MEMORANDUM

Subject: Prado Perimeter Center, LLC owner of 121 Perimeter Center West, tax parcel 18-349-05-029, by Dennis J. Webb, Jr., attorney for the owner, seeks the following:

1. **MA17-02:** Request to modify previous zoning conditions;
2. **SLUP 17-04 A):** Section 27-23(b) to vary maximum building height in and OCR (Office, Commercial, Residential) District from 2 stories/35 feet to a 7-story hotel and five-story parking structure;
3. **SLUP 17-04 B):** Section 27-98(b)(6) to vary the Minor Parkway Street Type requirement (Perimeter Center Place); and
4. **SLUP 17-04 C):** Section 27-98(b)(7) to vary the Primary Street Type requirement (Olde Perimeter Way).

Figure 27-98-12 Minor Parkway Frontage Option - Parking Edge

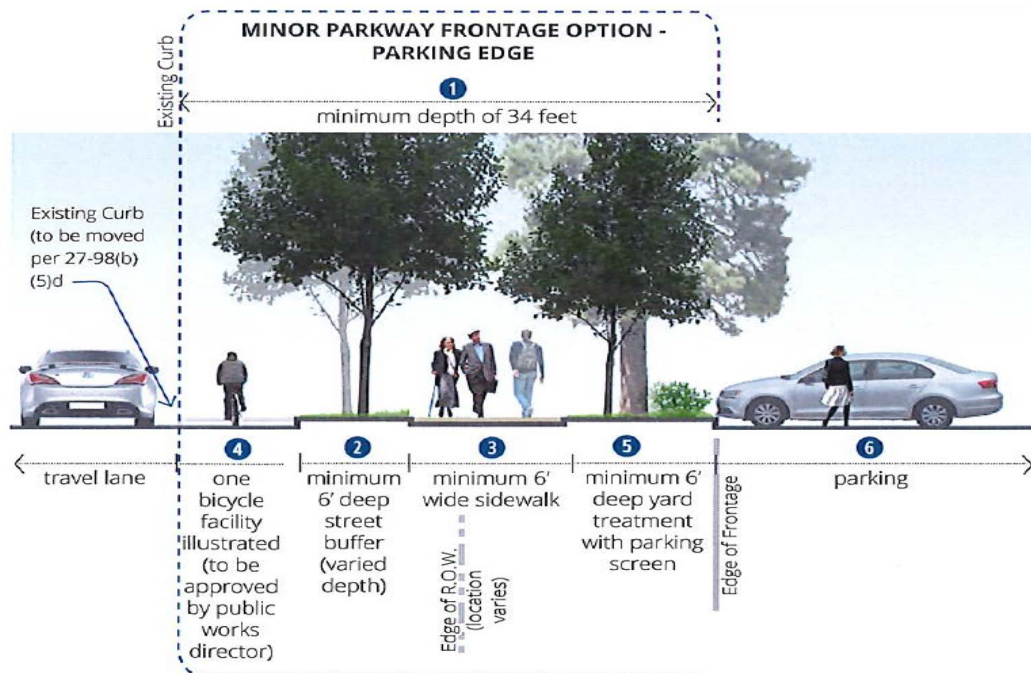
Perimeter Center Place is listed as a Minor Parkway that requires a minimum 6-foot street buffer with street trees, 12-foot shared use path (or 6-foot sidewalk with separate bike lane), and 6-foot yard treatment to building location. Due to an underground gas line, the applicant is requesting to move the street trees from the street buffer to the landscape buffer, located on the other side of the sidewalk. With the exception to the location of the street trees, review of the site plan indicates that the proposed streetscaping meets all other aspects of the minor parkway frontage requirements (see section below). Staff is of the opinion that full compliance along Perimeter Center Place can be waived if, during the Land Disturbance Permit process, the applicant can substantiate the exact location of the gas line. In response to this request, condition 16 has been added to the recommended list of conditions, wherein during the land development phase, the Community Development Director will review information provided by the applicant to determine whether or not the trees need to be moved.

1. Section 27-98(b)(6): Minor Parkway Street Type requires a separate bicycle lane, 6-foot street buffer, and 10-foot sidewalk (Perimeter Center Place);

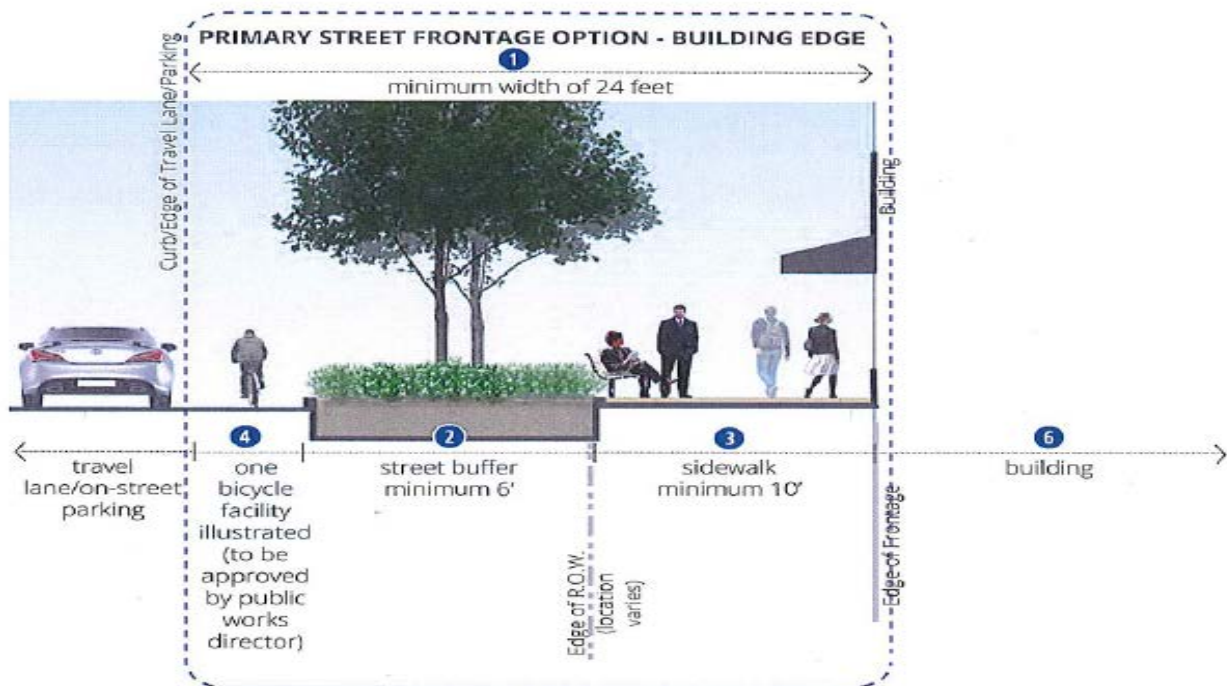
2. Section 27-98(b)(7): Primary Street Type requires a separate bicycle lane, 6-foot street buffer, and 10-foot sidewalk (Olde Perimeter Way);

CONCEPTUAL
SITE EXHIBIT

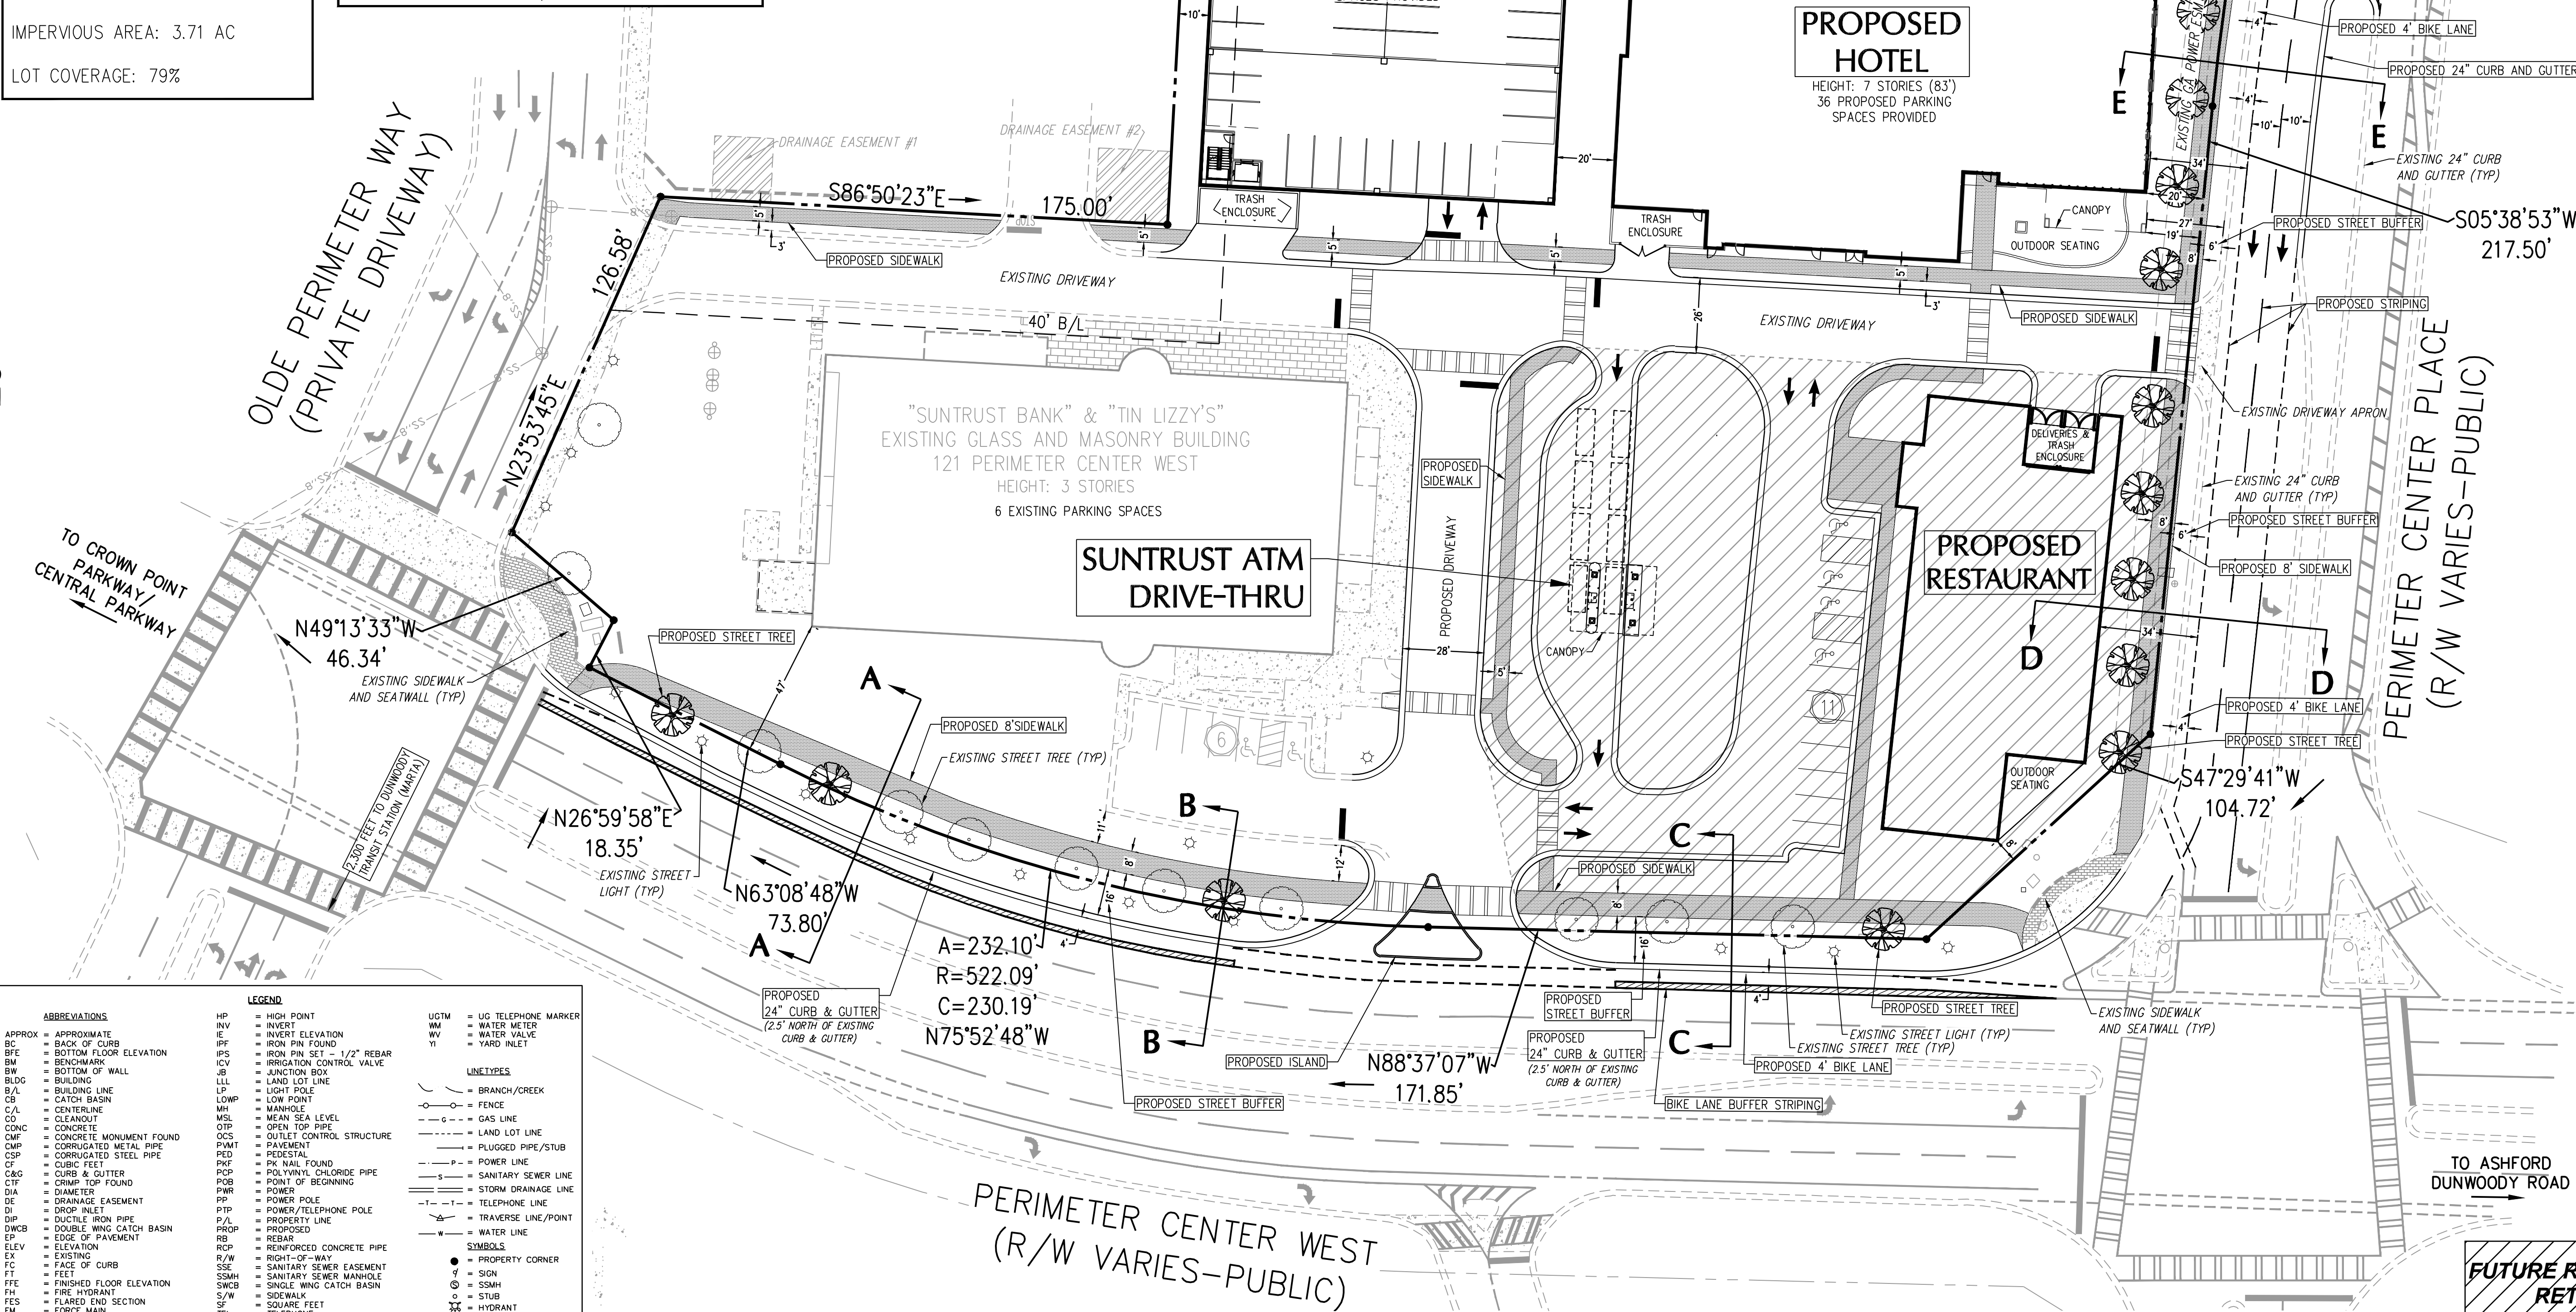
1. Unless otherwise approved, the site plan shall be modified to be in compliance with all Perimeter Center Overlay and all zoning requirements.
2. The total density on the Property shall not exceed (a) an existing $\pm 50,000$ square foot, three-story office building with office, commercial, financial services, retail and/or restaurant uses; (b) a seven-story, 157 room hotel; (c) a single-story standalone restaurant space of up to 10,000 square feet; (d) a standalone, two-lane bank drive-thru; and (e) a five-story parking deck, accepting that the Owner may construct up to a combined total of 15,000 square feet of new restaurant, retail sales, commercial and/or office space in the cross-hatched area on the Site Plan if it

10. Applicant should provide a Transition Yard 2 on the side (west) and rear (north) of the parking deck. Such Transition Yard shall contain no surface parking.

11. The applicant shall remove the bypass lane found at the drive-thru.
 12. The proposed driveway off of Perimeter Center West should be reduced in width from 28 feet to 26 or less.

15. Within the cross-hatched area shown on the plans, the uses are limited to a bank drive-thru and restaurants.
 16. During the Land Development Permit process, applicant shall show the exact location of the gas line in relation to the intended location of the street trees along Perimeter Center Place. Based on the information provided, the Community Development Director will review and determine whether the street trees on Perimeter can be planted between the sidewalk and the road as shown in the Perimeter Center Overlay. If it is determined that the gas line will not impact placement of street trees, the street trees will need to be planted per streetscape requirements for a Minor Parkway Street Type.

**CONCEPTUAL
LANDSCAPE PLAN**

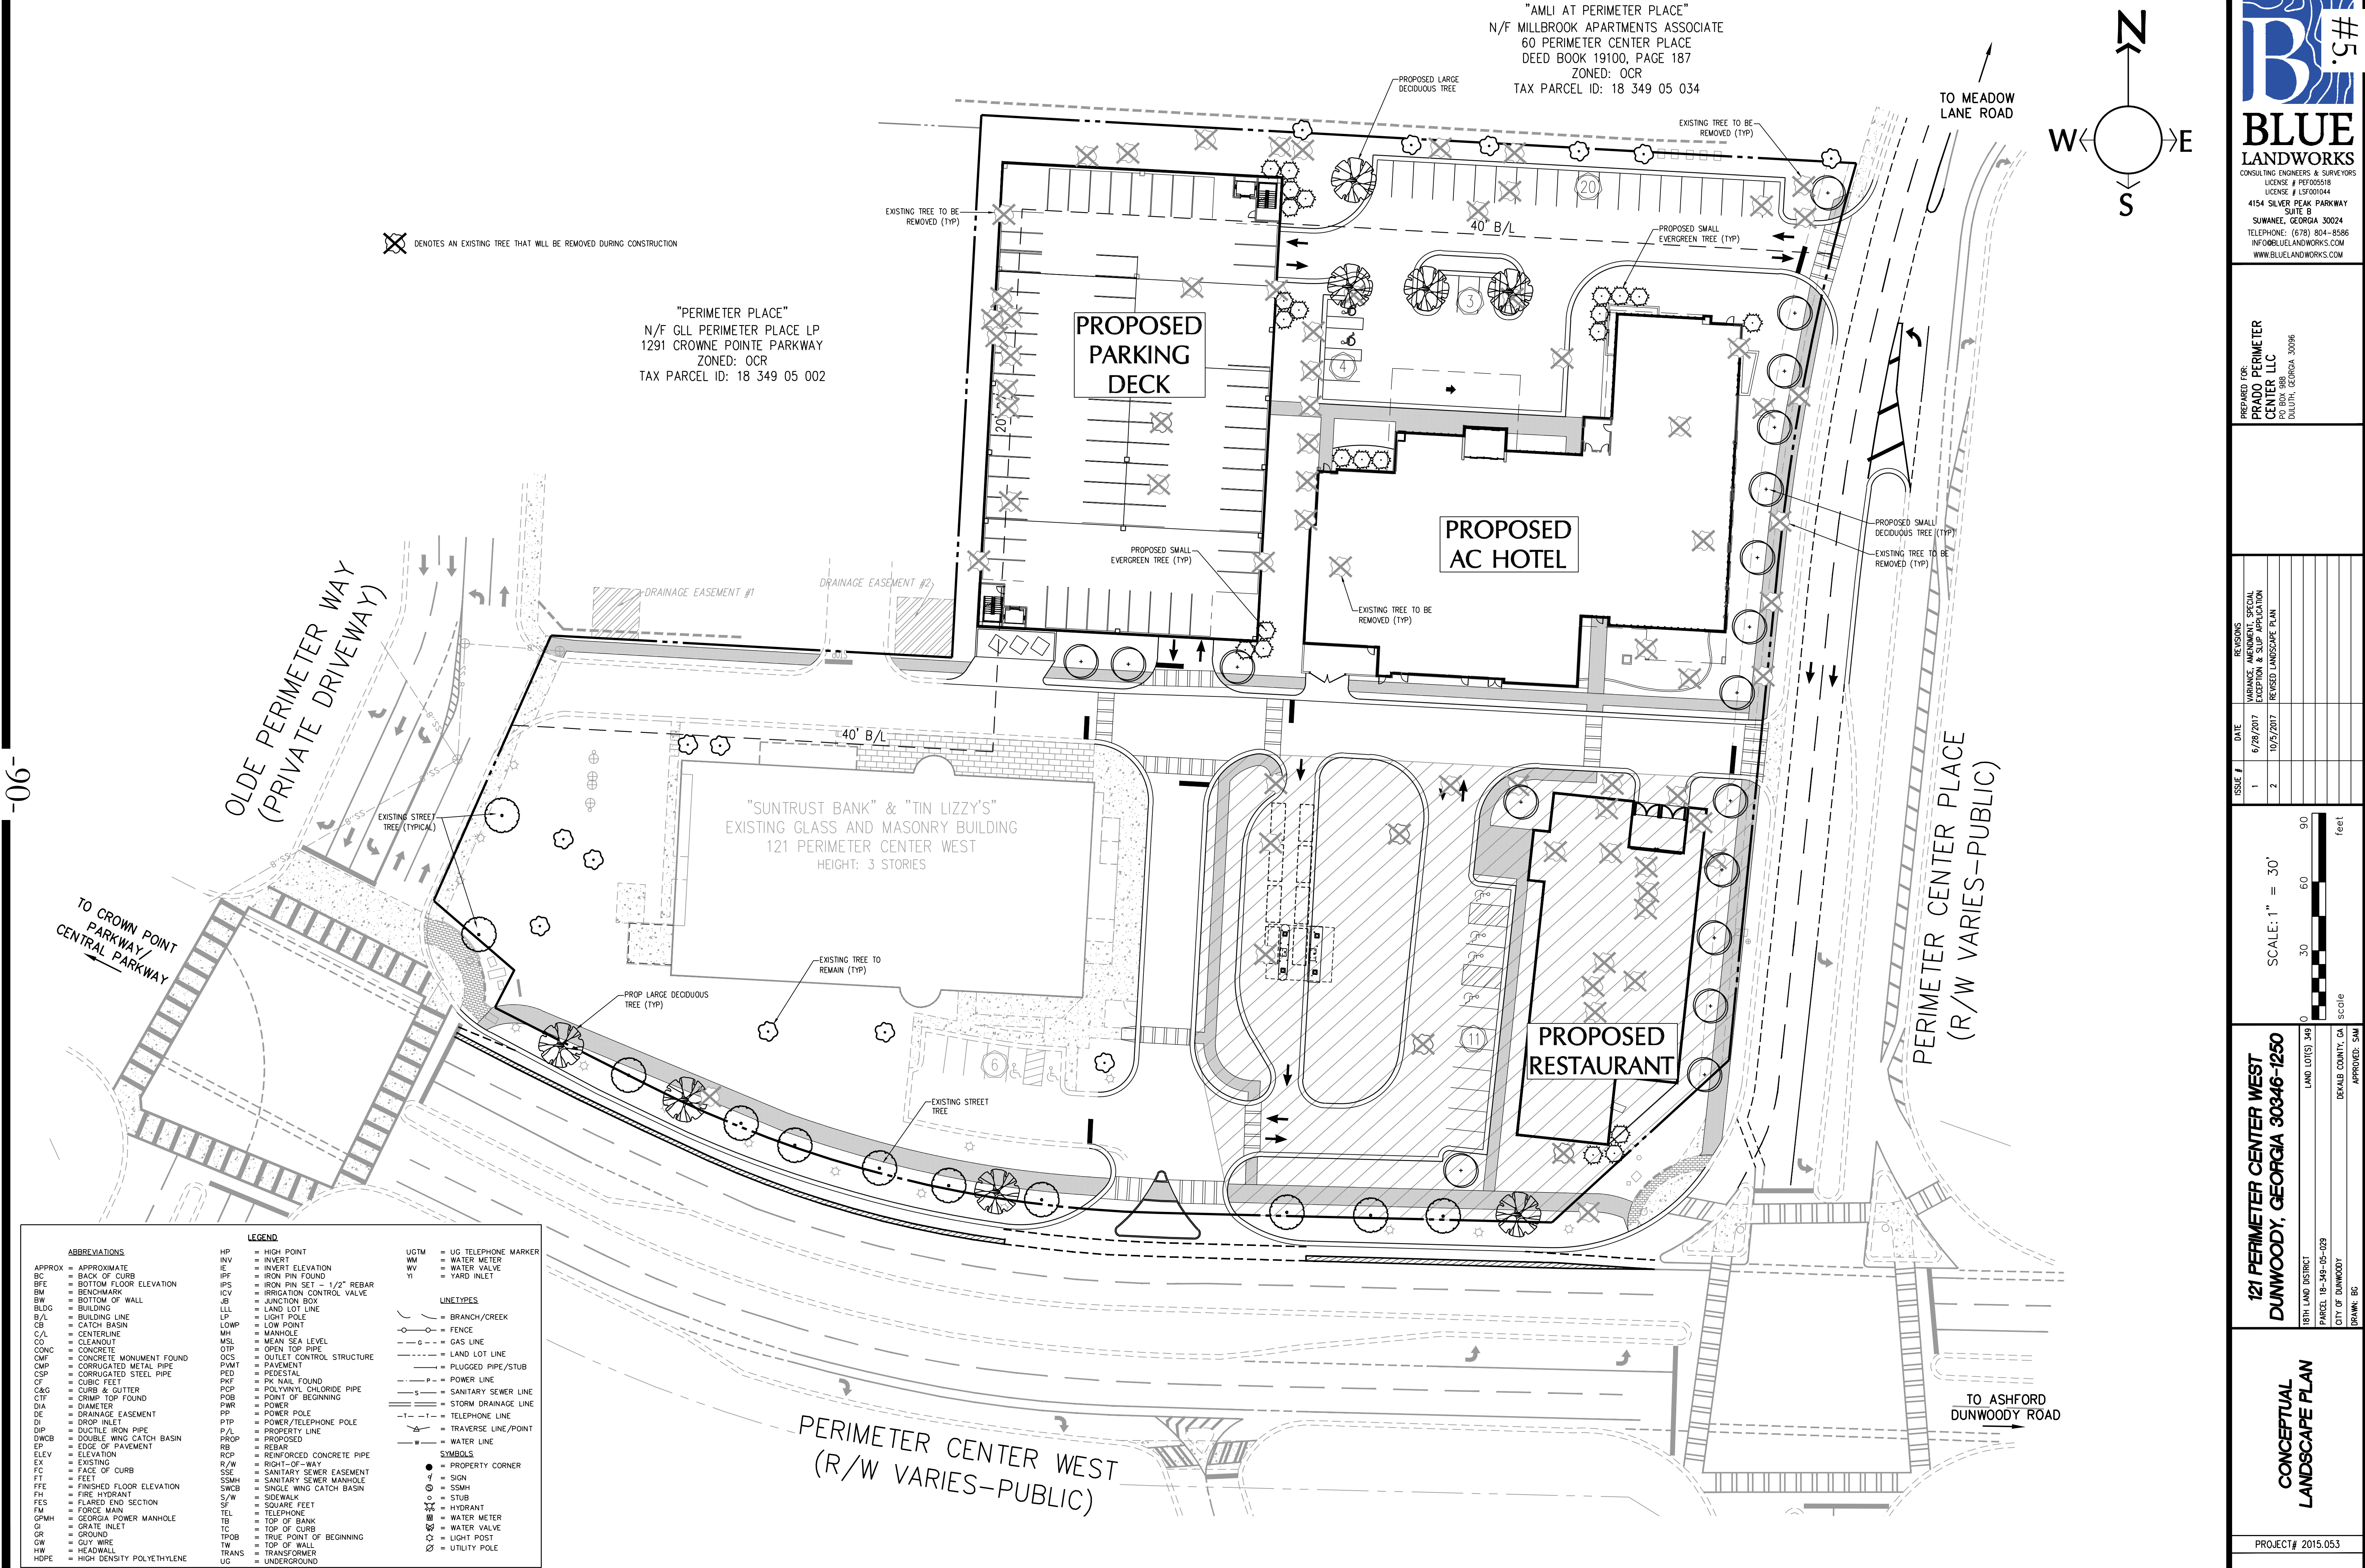
Approximately 63 existing parking lot trees, including 14 willow oak specimen trees, are proposed to be removed for grading and land development. Of the specimens, three have a diameter breast height of 24 inches, one is 28 inches, one is 29 inches, one is 30 inches, one is 38 inches, and seven are 32 inches. Review of the site plan indicates that five trees internal to the site and 11 existing street trees will be saved. As well, 17 additional street trees are proposed to be planted along the site's perimeter street frontage, located along Perimeter Center West. In an effort to save mature oak trees on the site, staff has added condition 17, which states that the applicant will save the 38 inch willow oak at the corner of Perimeter Center West and Perimeter Center Place, and prior to issuance of land development permit submit a landscape plan that attempts to save other specimen sized oaks on the property. Should the applicant be able to save additional trees, the condition allows the Community Development Director to approve of a revised site plan. Finally, condition 18 requires the applicant to plant 60% of the street tree plantings as 4" DBH trees.

17. During the land development phase, the applicant shall work with the City Arborist and Community Development Director to save the 38" Willow Oak at the corner of Perimeter Center West and Perimeter Center Place. Further, prior to the issuance of land disturbance permit, the applicant shall submit a landscape plan to attempt to save some of the specimen sized oaks on the property. In the event that the site plan needs to be amended to save trees, the Community Development Director is authorized to approve of a revised plan.

18. A minimum of 60% of the trees proposed for planting on the landscape plan shall be 4" DBH, unless otherwise approved by the City Arborist.
 19. The Community Development Director must approve the removal of existing trees on the site prior to the construction of a restaurant.
